Product Change Notification

Date Issued :	March 28, 2025	PCN Number :	516665
Reason for Change :	Change to Product		
Description of Change :	This notification is to inform you about changes that are being made to the part(s) as identified in the list. This change not affect the Fit, Function of the parts.		
Reason for Short Notice :	Corrective Actions		
Assessment of Change :	First Article Inspection		
Planned Implementation Date :	June 30, 2025		
Customer Sample Availability Date:	May 20, 2025		
Last date to request Samples by Customer :	May 20, 2025

- Change description of Mini Fit TPA2 200453 series

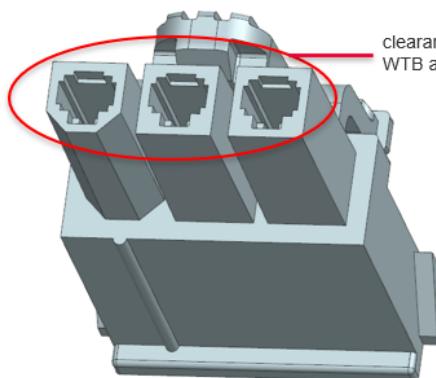
- We are adding the wire-to-board application for Mini Fit TPA2, Molex identified an improvement in the mating by optimizing the structure. The mold to produce the TPA2 200453 series will be changed.
- Product Impact
 - No impact to wire-to-wire application
 - No impact to fit, function
 - Form and appearance will be impacted as shown in after photo above
- Part Number Impact
 - See attached impacted parts list
- PCN will be implemented once all required qualification/validation has been completed, and necessary approvals have been obtained
